Record of Decision
Photocircuits Corporation
Operable Unit No. 1
City of Glen Cove, Nassau County, New York
Site Number 130009

March 2008

DECLARATION STATEMENT - RECORD OF DECISION

Figure 2 - Site Map

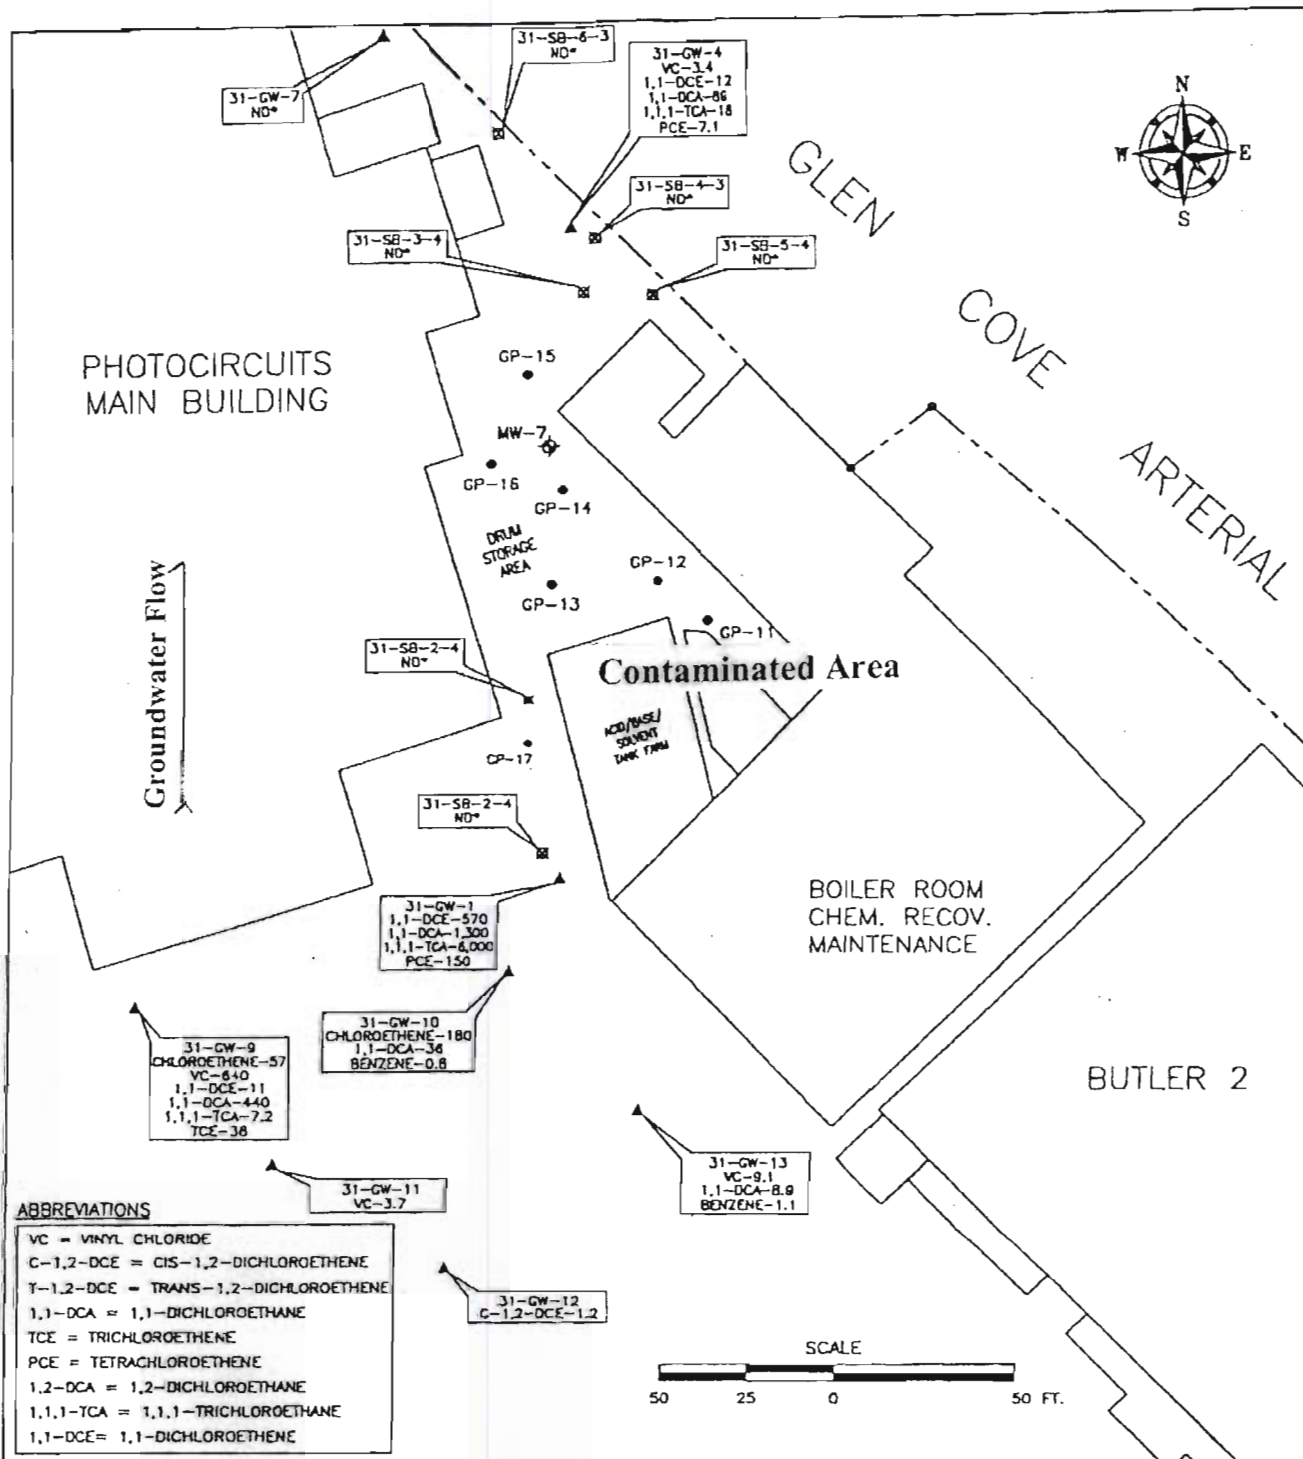
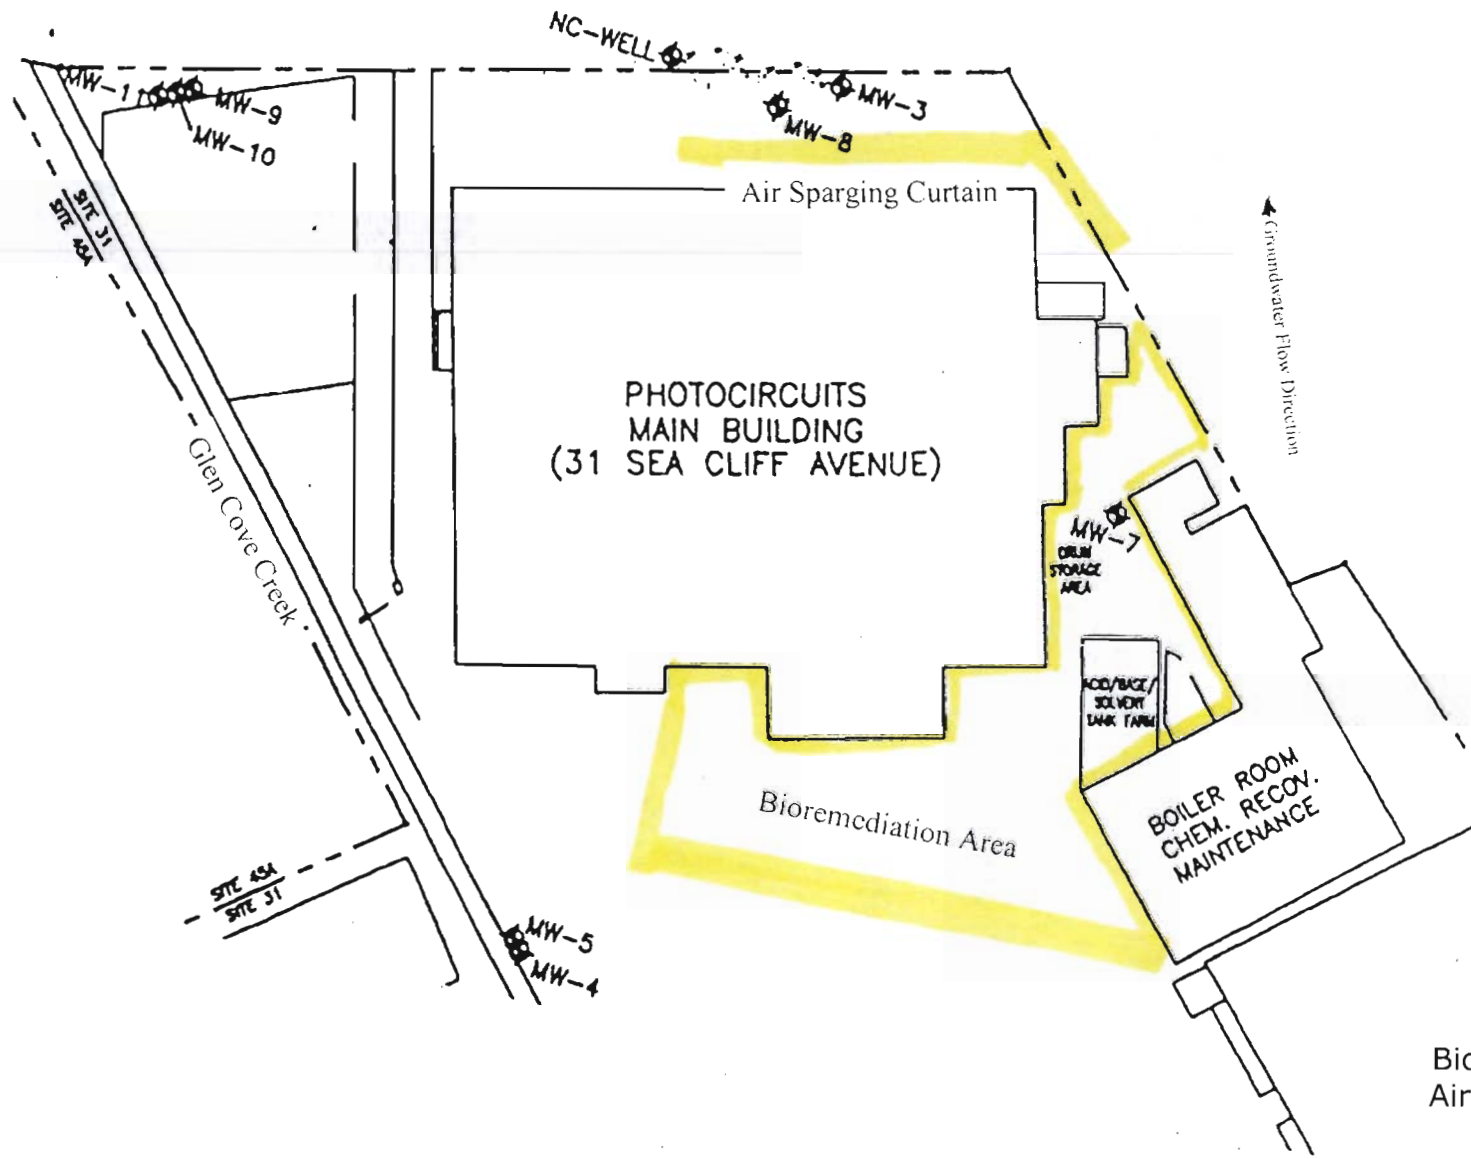
COMMENT 34: Comment 5: P. 4, Para 2, Line 2: A comparison of Figures 2 and 3 indicate that much of the Photocircuits property, including the entire area near Butler 2 was never investigated. This would result from the fact that only a Focused Remedial Investigation was performed. The NYSDEC should include data for other areas of the site, if any exist. If no additional data exist, additional investigation - including sampling within the building footprint underlying

RESPONSE 34: Investigations performed prior to the FRI include the "Source Area Investigation for the Sea Cliff Industrial Area" performed in 1992, and the "Preliminary Site Investigation" performed in 1996, both cited in the PRAP. These reports identified the drum storage and tank farm areas located to the east of the Photocircuits' main building as the primary areas of concern at the site. Inclusion of the data from these investigations is beyond the scope of a PRAP, however, both documents are available in the repositories.
